CODE COMPLIANCE CERTIFICATE

Building Consent No:	055884	Issued by:	Kapiti Coast District Council
Project Description:	Construction of garden shed away from house and removal of one internal wall in house

PROPOSED ADDITIONS AND ALTERATIONS FOR MR. ALLEN
43 KOHEKOHE ROAD - WAIKANAE

PROPOSED ALTERATIONS FOR MR. ALLEN
43 KOHEKOHE ROAD - WAIKANAE.

EXISTING GROUND FLOOR PLAN
WITH ALTERATIONS. 1:100

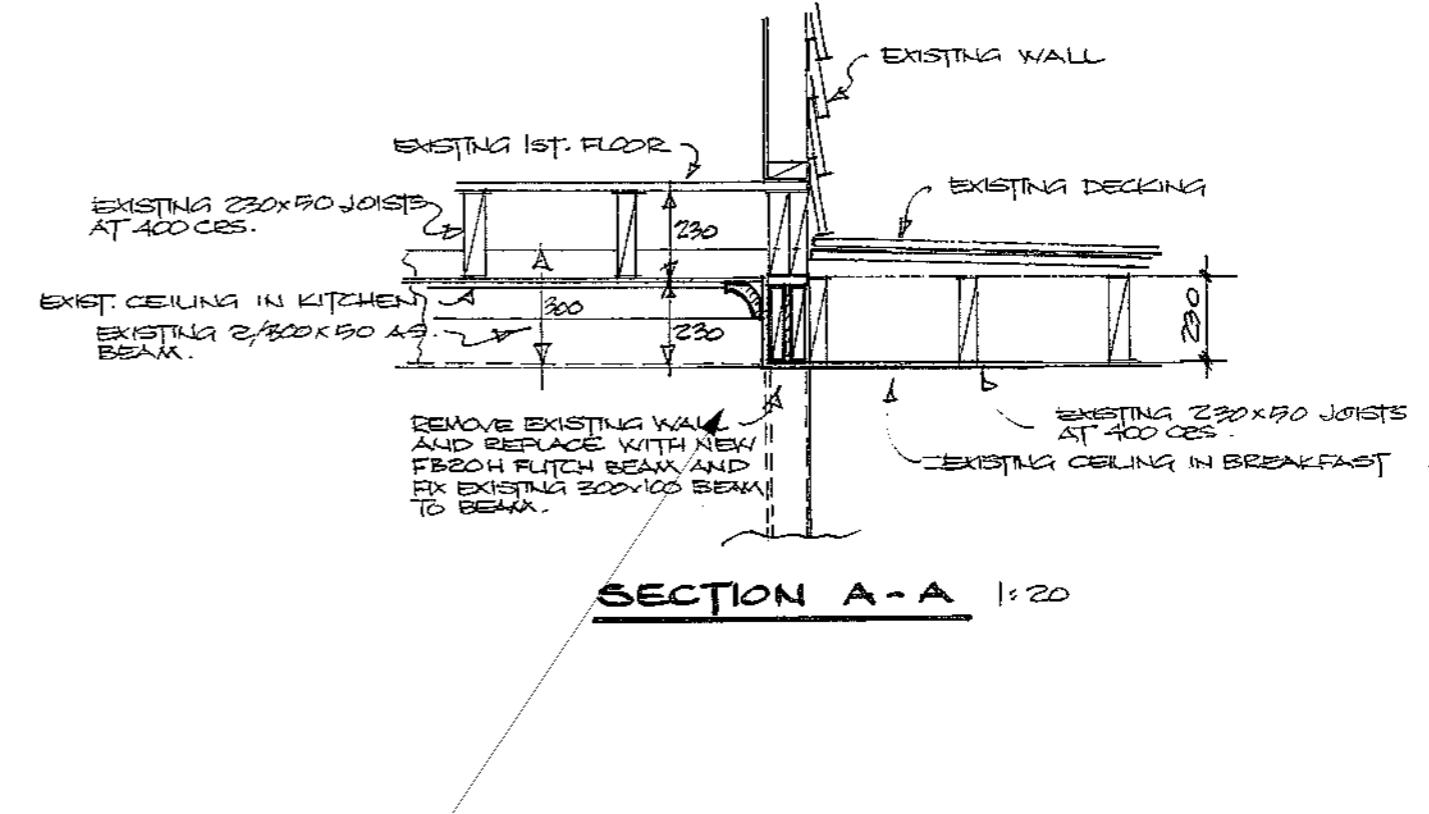
this flitch beam is not uniformly loaded as the existing beam attaches approx' midspan.

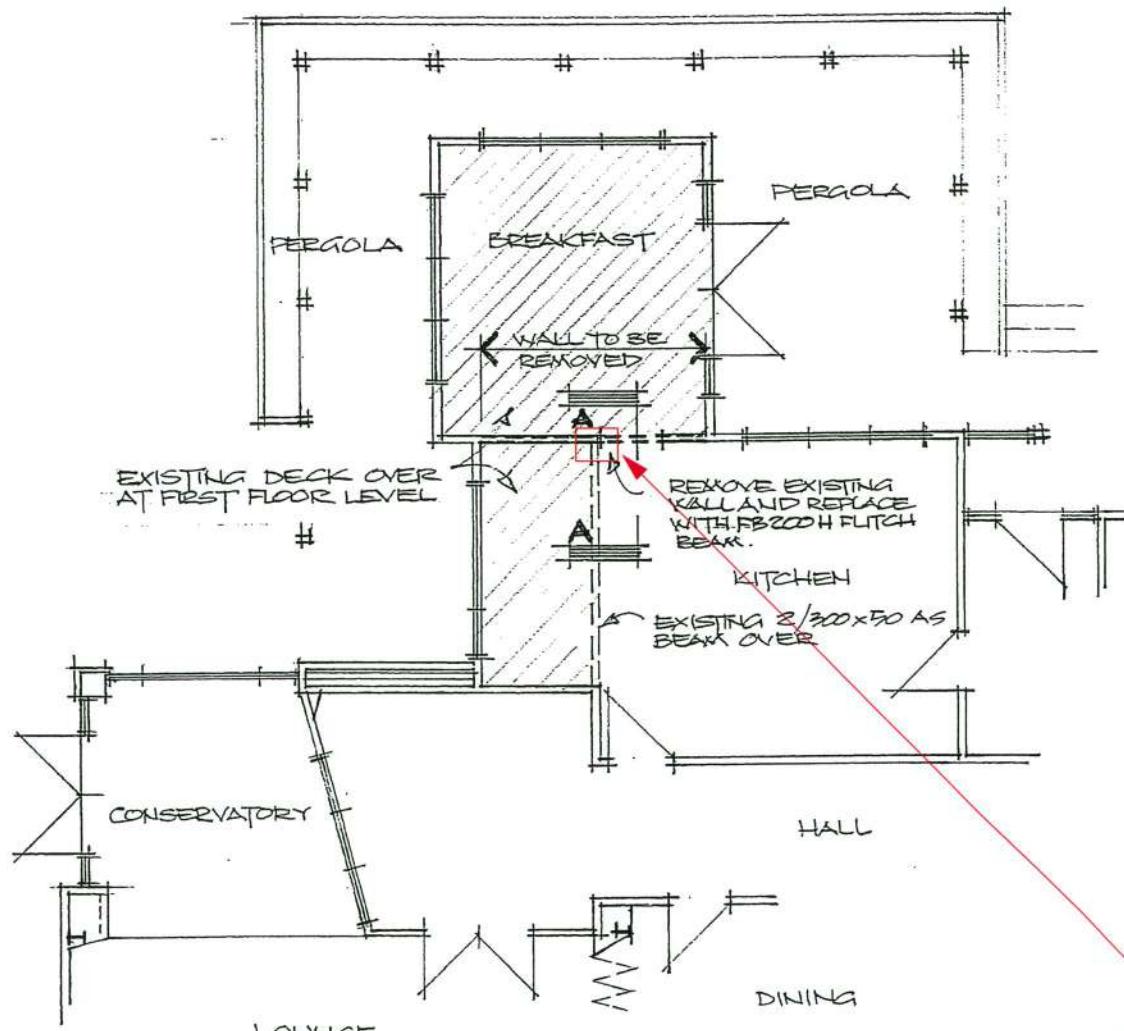
stormwater to be taken clear of the foundation
and contained on site.

EXISTING GROUND FLOOR PLAN
WITH ALTERATIONS. 1:100

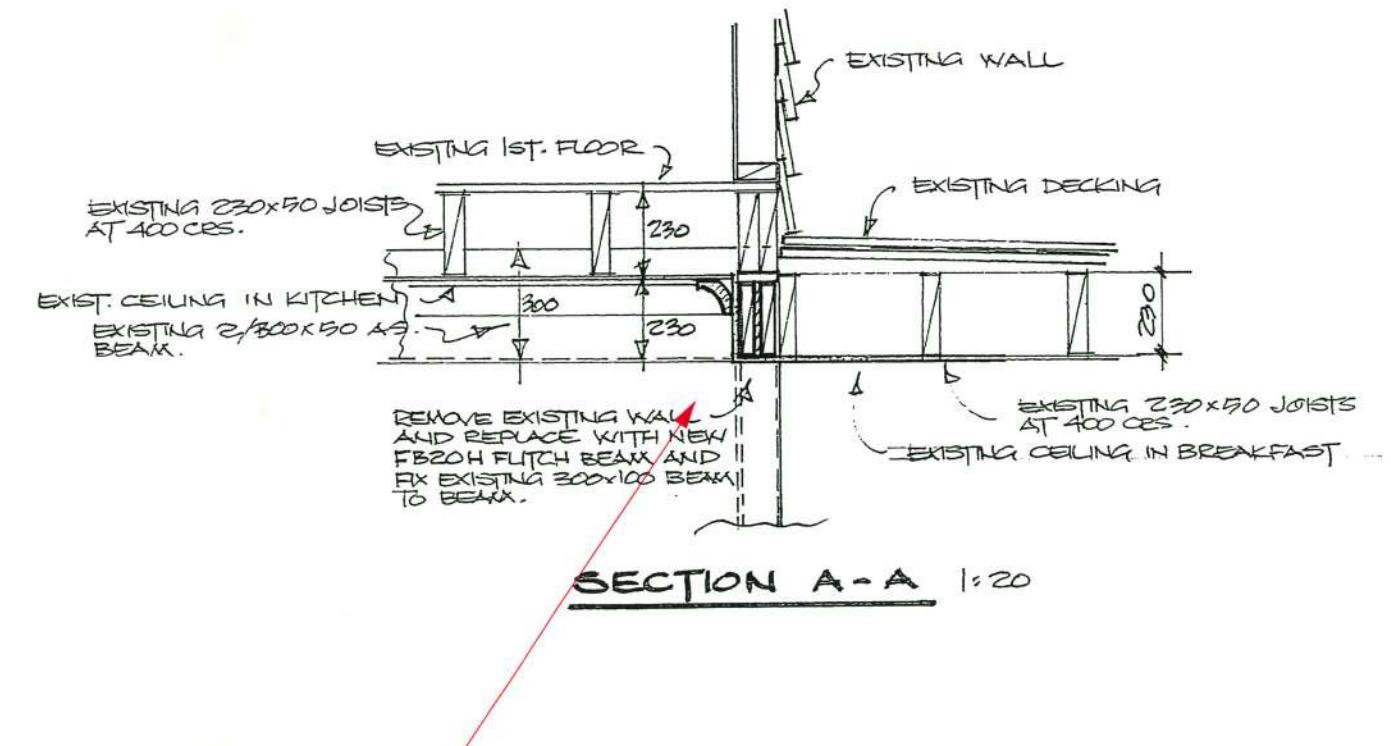
this flitch beam is not uniformly loaded as the existing beam attaches approx' midspan.

CROSS SECTION 1:50

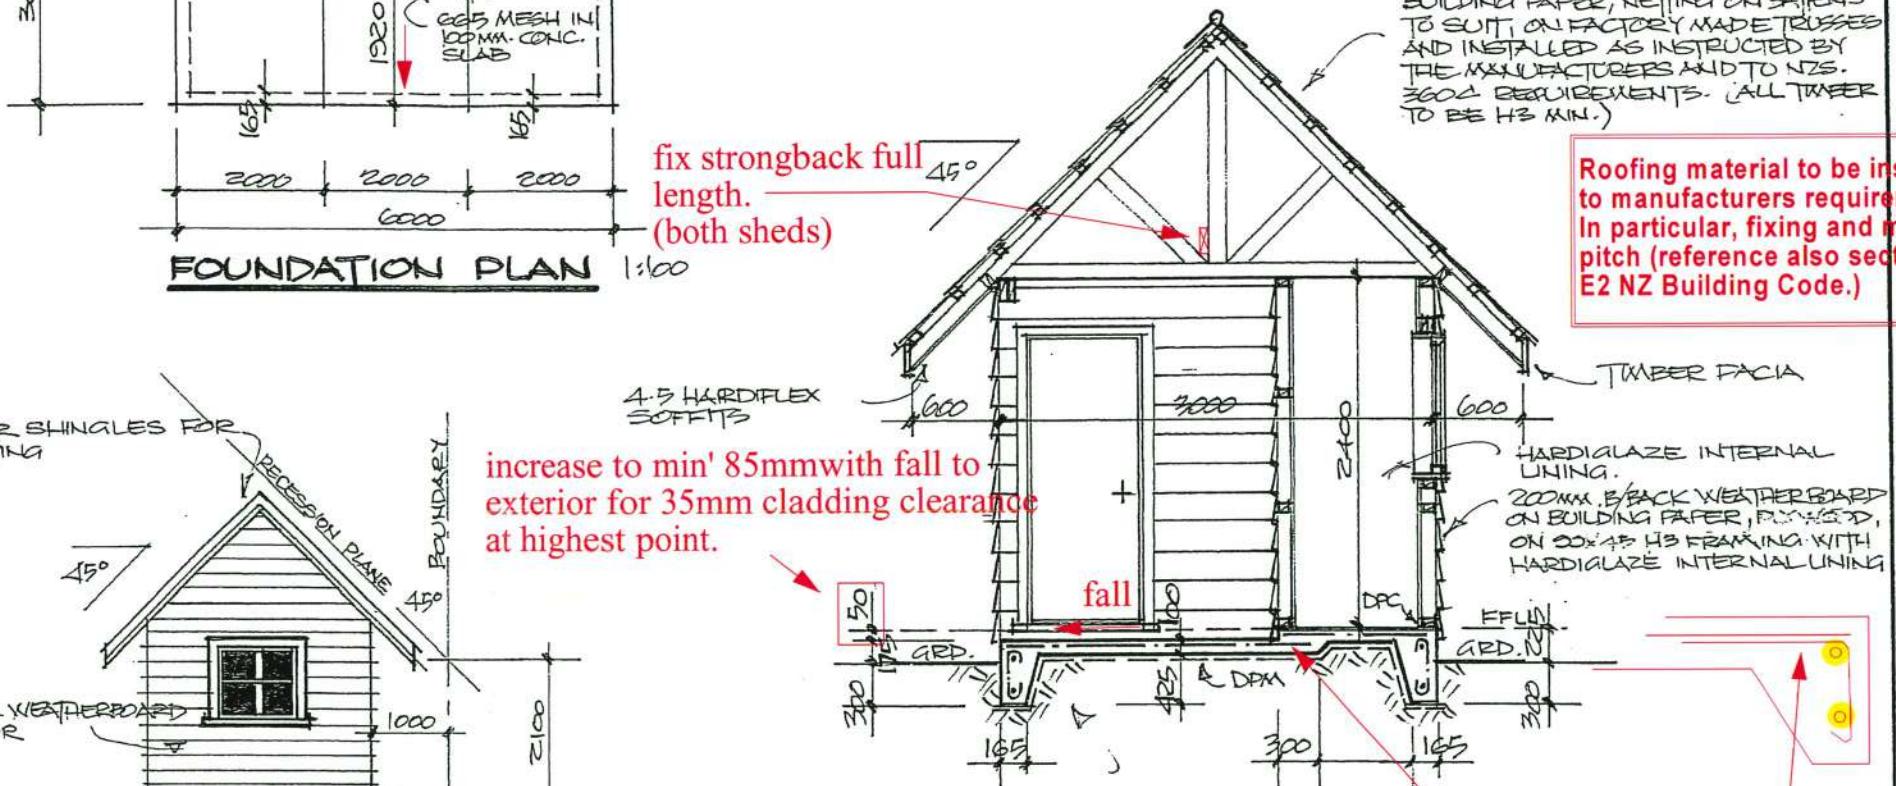
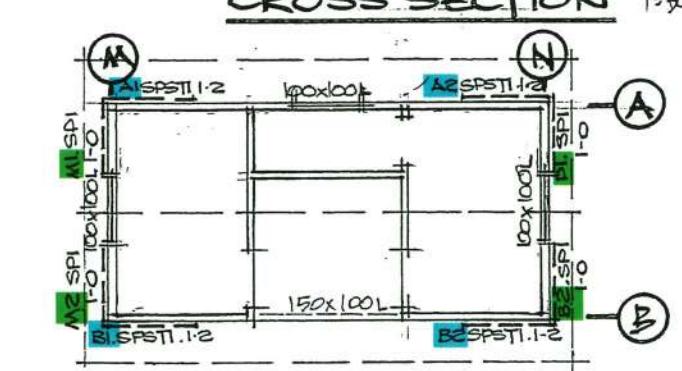
increase to min' 85mm with fall to exterior for 35mm cladding clearance at highest point.

2/D12 bars within the slab thickening

lap steel ties 300mm with floor mesh
